TENDER 16-20

WATER TREATMENT BUILDING

ADDENDUM NO. 8

October 20th, 2016

TITLE:	PROPOSED RAW WATER SUPPLY MAIN HIGHWAY #28 PHASE 1 CIVIL DETAILS	DRAWING NO.	13-508- D3
		PROJECT:	112311316
		SHEET	9 OF 10
		REV

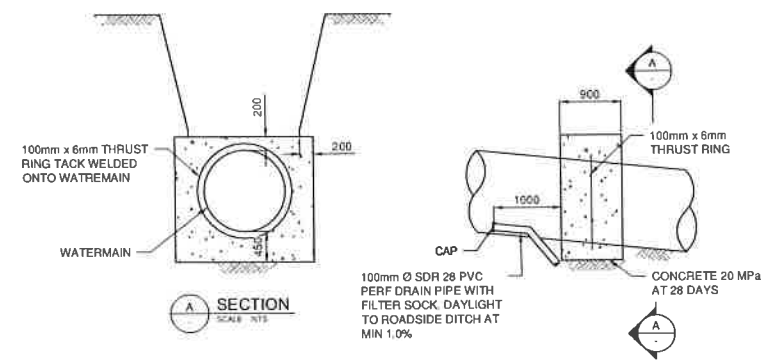
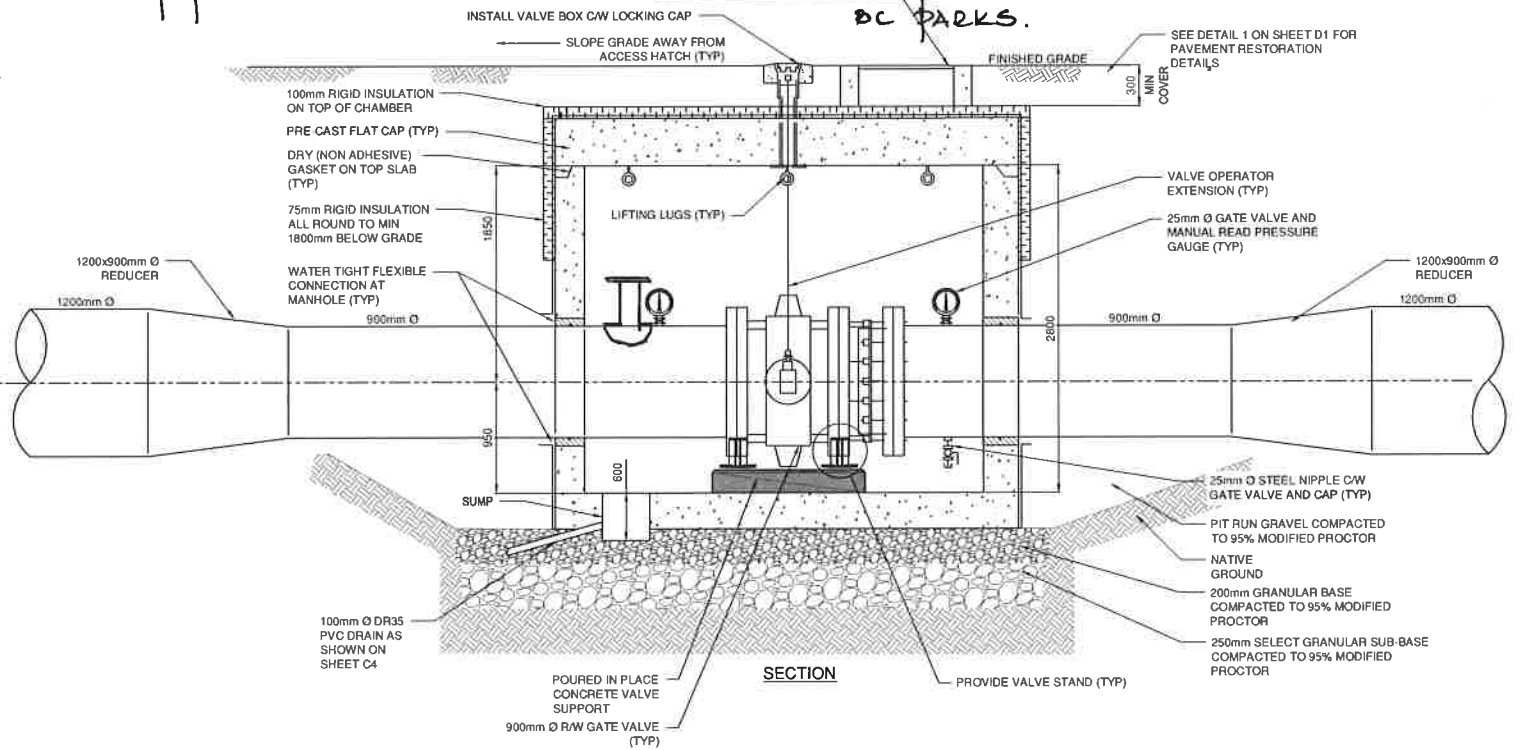
Air release valve to be installed in existing inline valve chamber on Highway 28. Hand sketch drawing 13-508-D3 Sheet 9 of 10 is attached.

CORE WALL B/W RE-BAR & INSTALL Ø 150 S/S SCHED 40 AIR VENT PIPE

ALSO SEE DETAIL DRAWING 13-508-D5 FOR 550m SECTION FOR AIR VALVE MODEL & PAINT COLOUR FOR VENT

TITLE: PROPOSED RAW WATER SUPPLY MAIN HIGHWAY #28 TREATMENT BUILDING - CONTRACT 2	DRAWING NO. 15-508- C201
JOHN HART WATER QUALITY CENTRE PLAN AND PROFILE	PROJECT: 11231316
	REV. 3

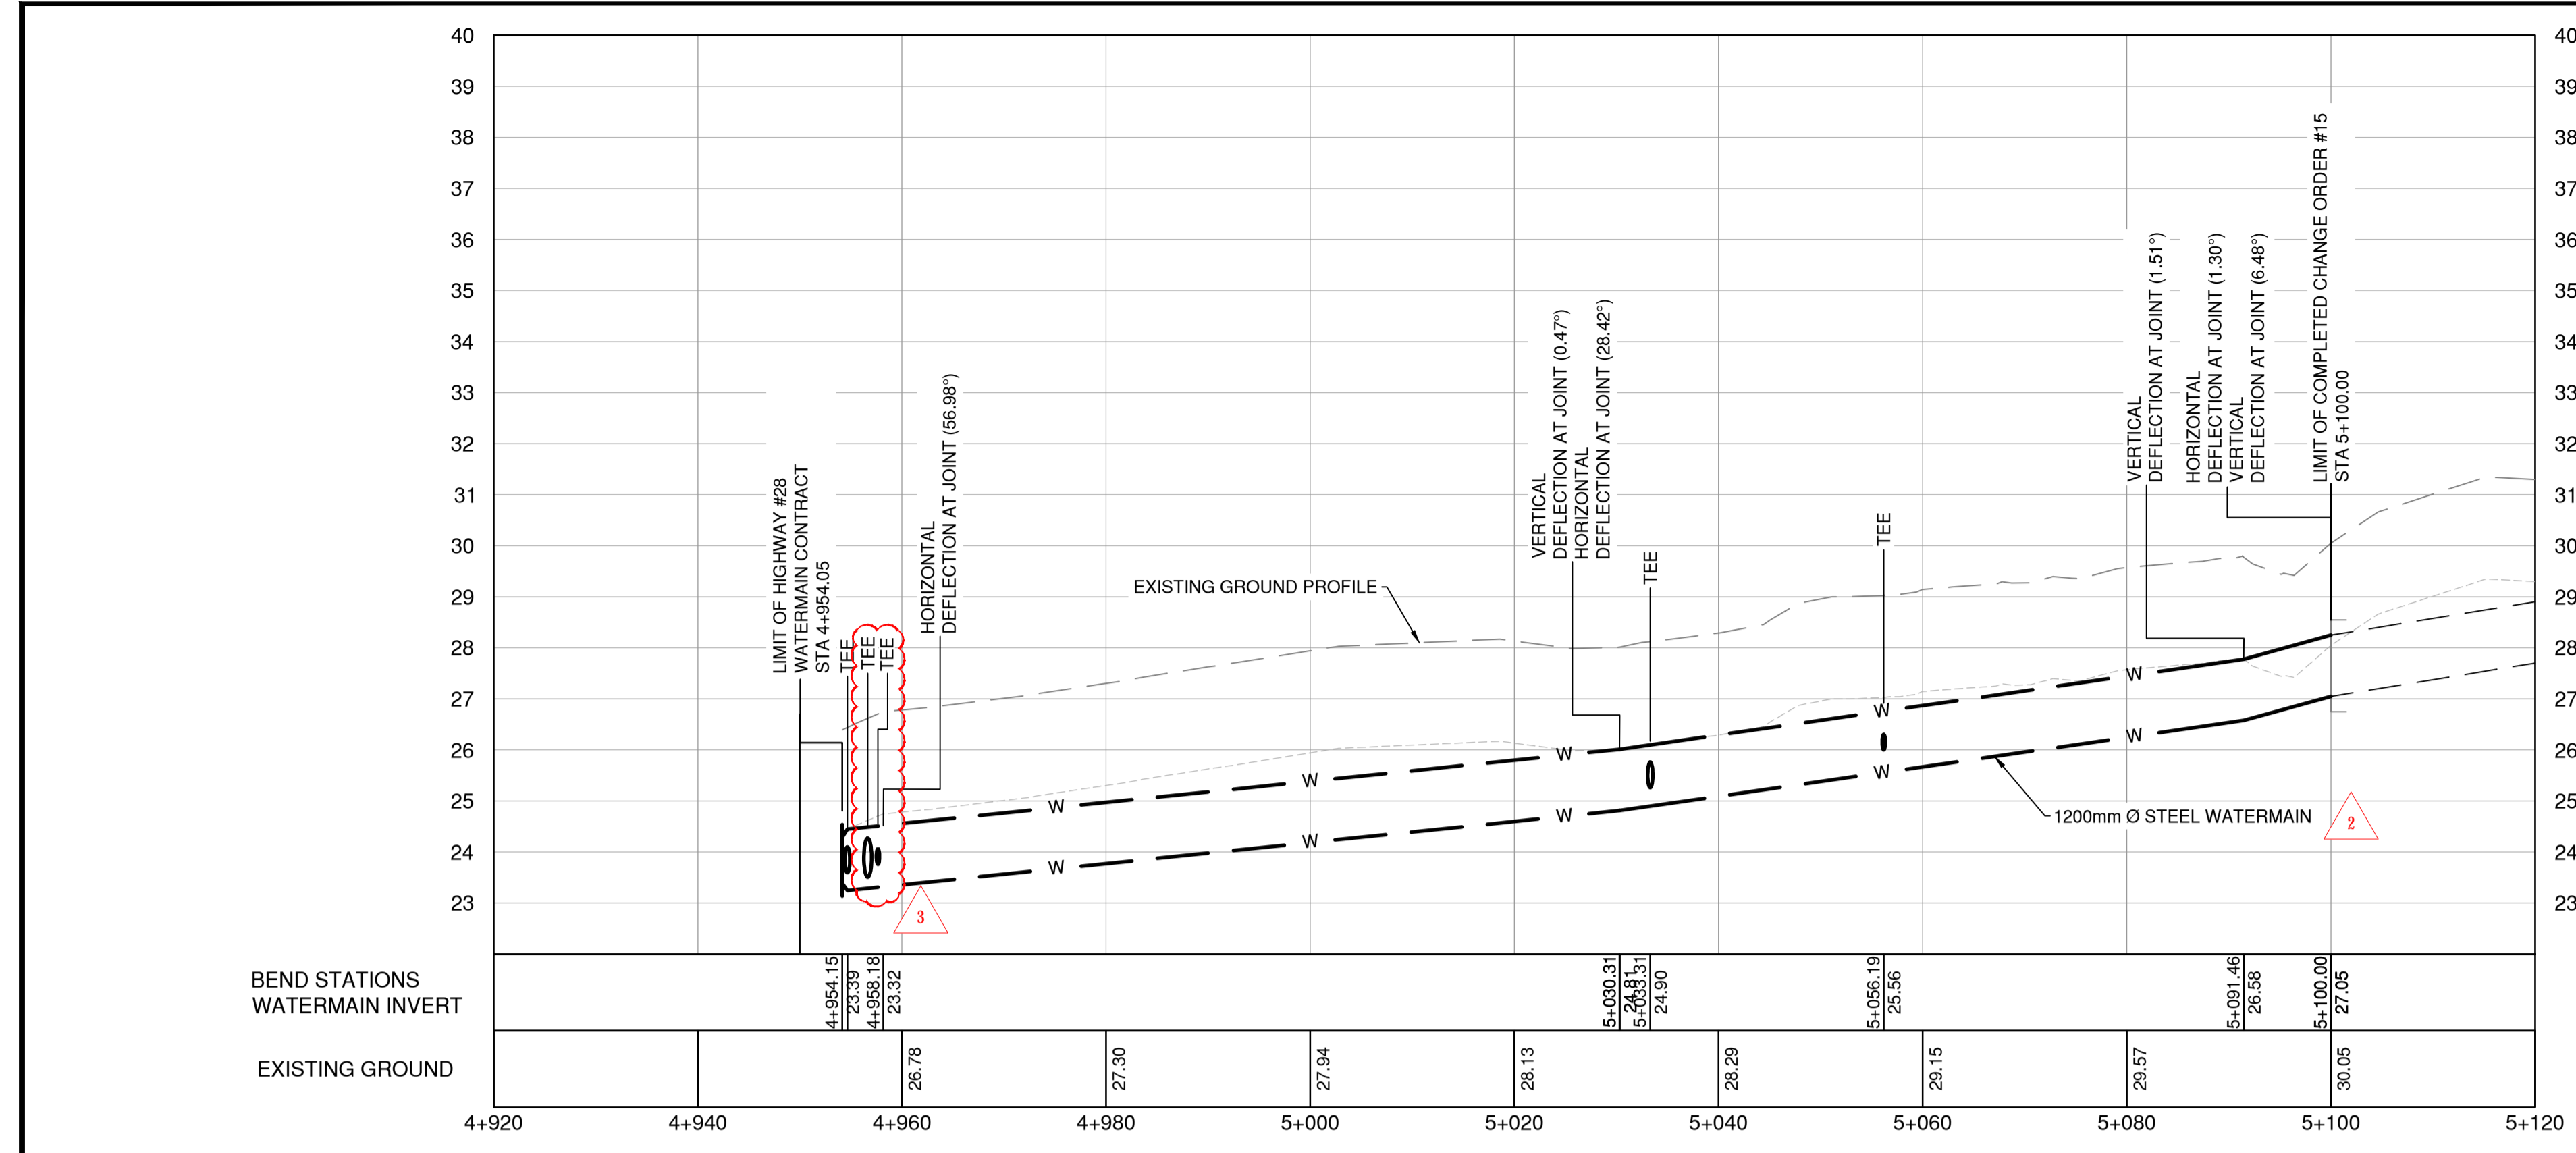
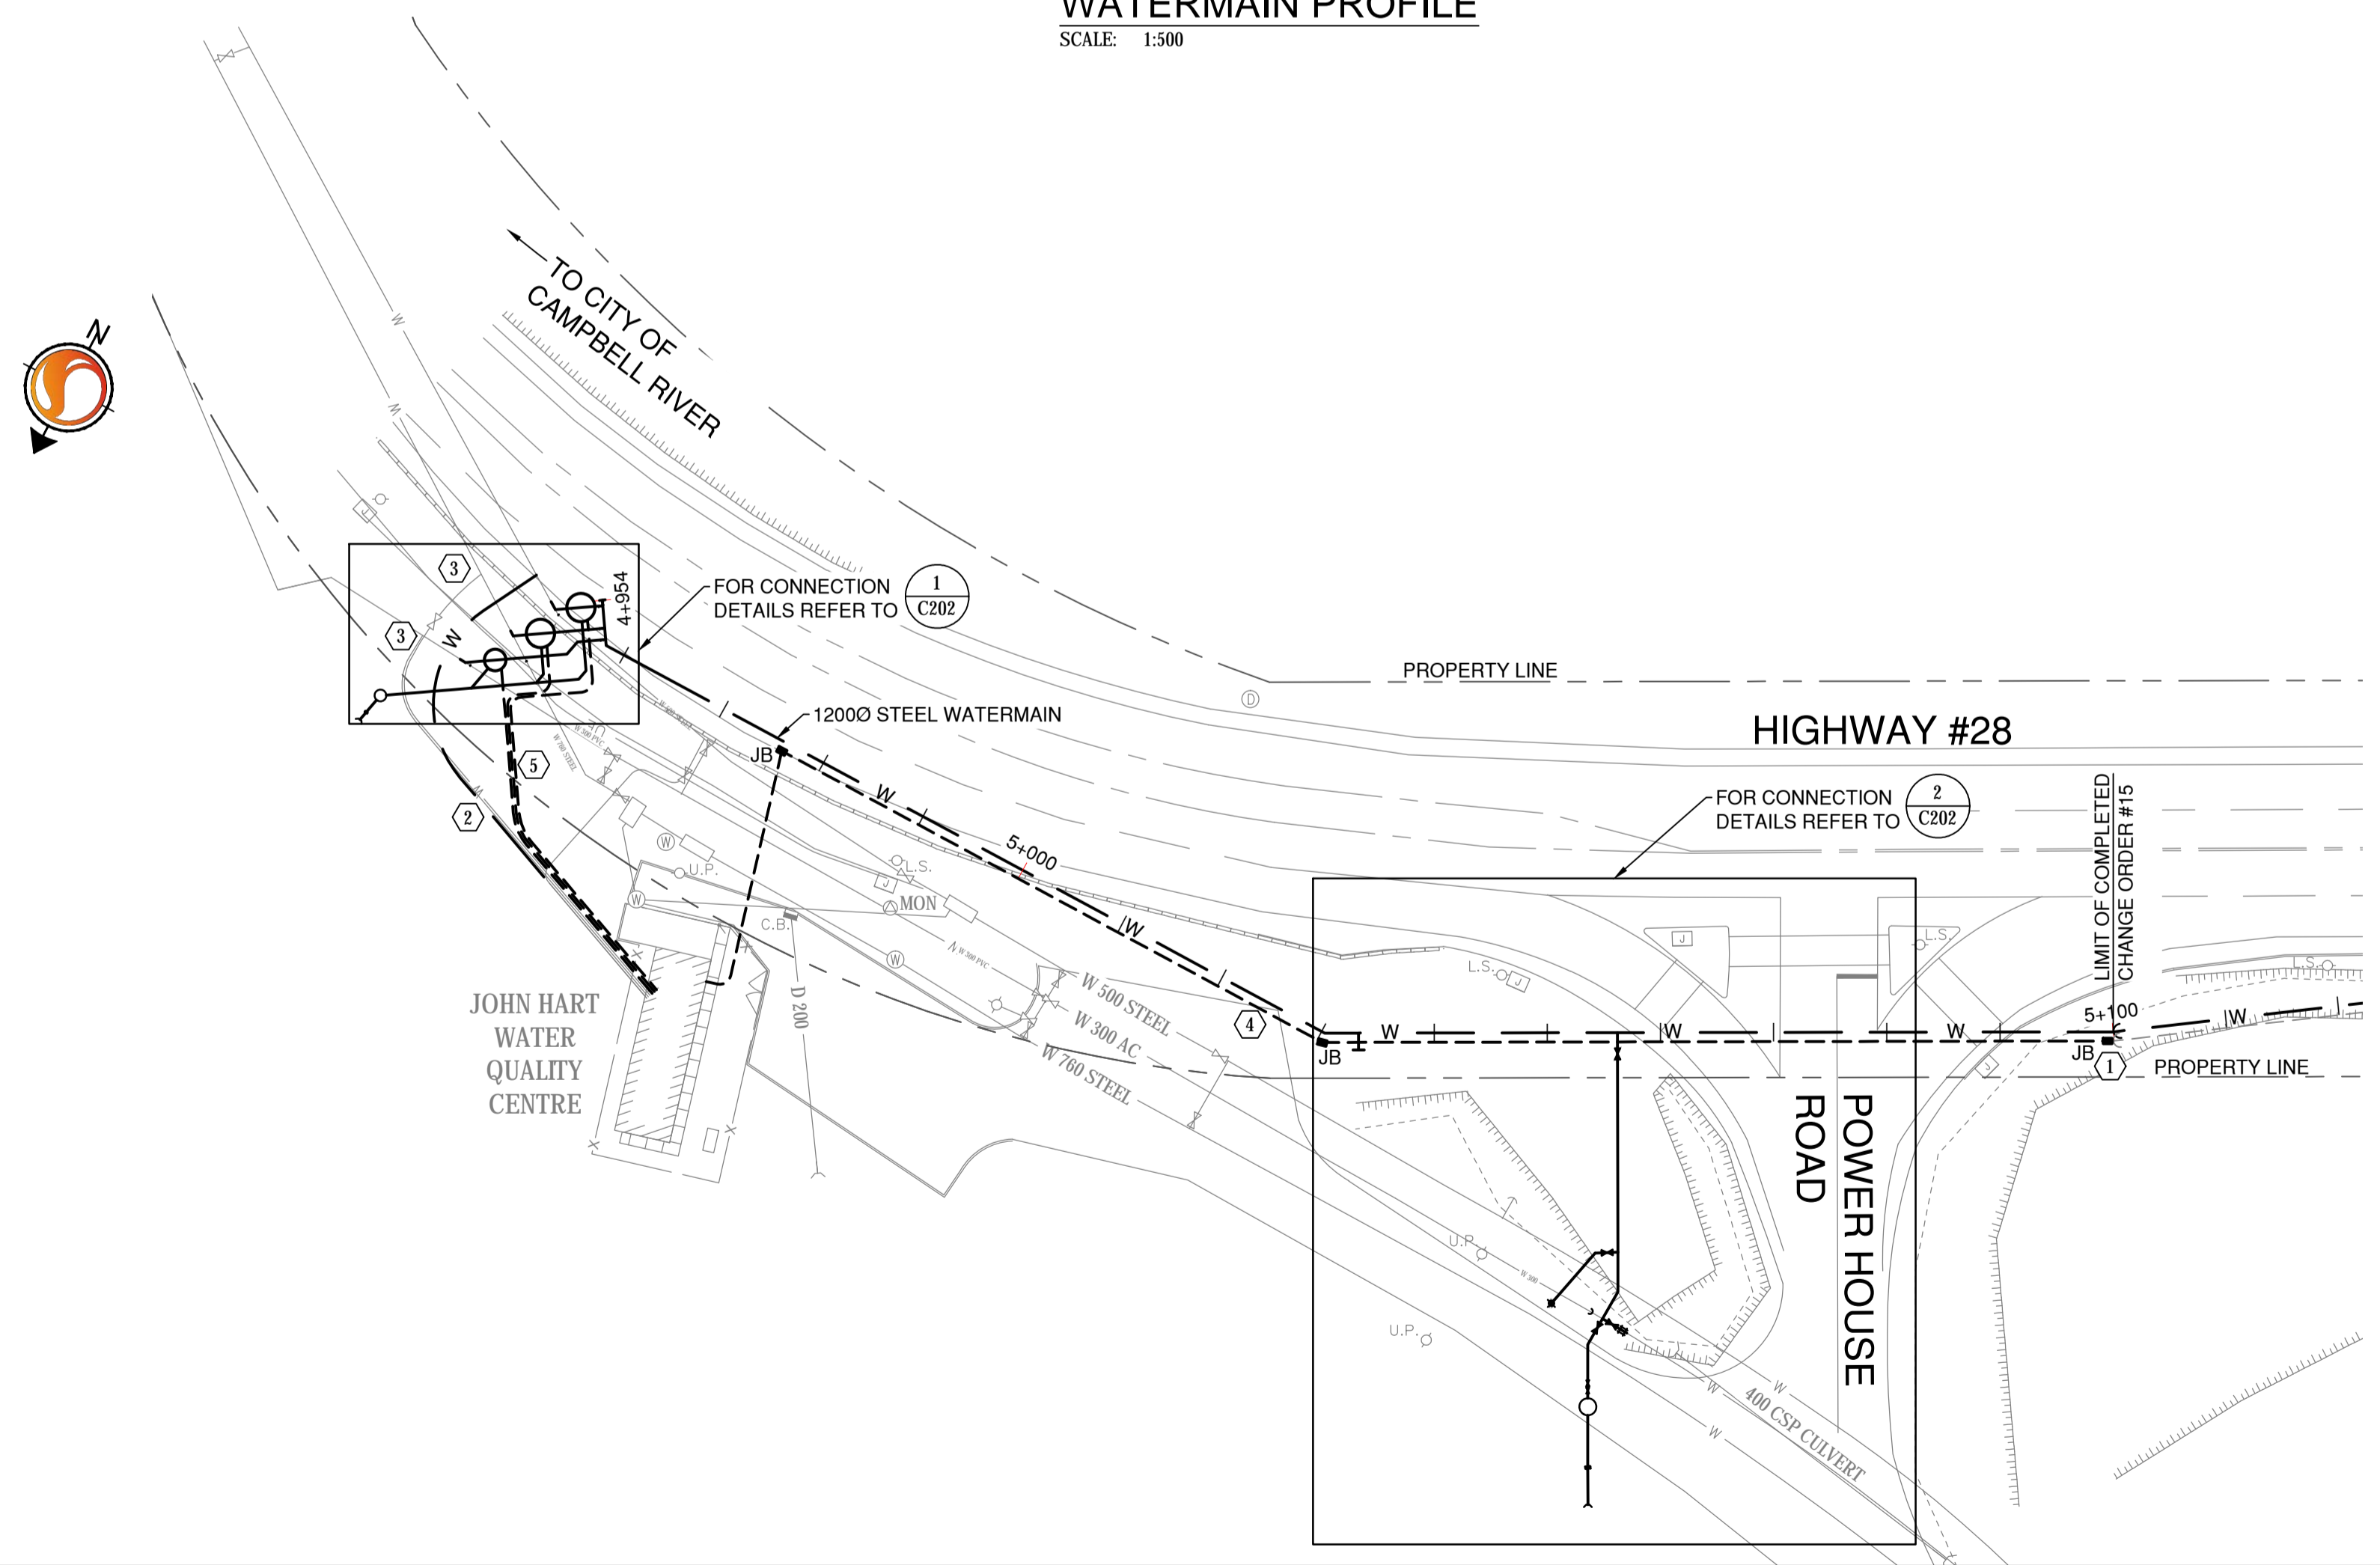
What is critical for the first tie-in, which is the 500mm, is to determine whether the 900 branch will pass over the existing 500mm upstream of the connection point. Please confirm that the 900 is to pass over top of the 500.

Extending the 900 branch at the time of the first tie-in up to and including the 900 x 760 x 300 Tee and valves is critical to the second tie-in of the 760 and 300 in order to isolate the first tie-in (1200 to 500). In order to facilitate the second tie-in it may be necessary, for safety concerns, to double valve the 760 and 300 at Note 3. These additional valves would remain in place as part of the final installation. The alternative to the additional valves would be to shut down the 1200 / 500 feeder during the second tie-ins. Is this shut down alternative to costly additional valves a possibility?

See revised layout on attached drawings C201 and C202. Valve on 760mm diameter line has been moved to the south west side of the 500mm dia. Main to allow the tie in to be isolated without needing to cross the 500mm diameter line. The 500mm diameter line can then be abandoned at the point where the 760mm dia. line crosses.

See revised layout on attached drawings. Valve on 760mm diameter line has been moved to the south west side of the 500mm dia. Main to allow the tie in to be isolated without needing to cross the 500mm diameter line. The 500mm diameter line can then be abandoned at the point where the 760mm diameter crosses to facilitate this crossing and the tie in to the 760mm diameter line following commissioning of the 500mm dia. tie in.
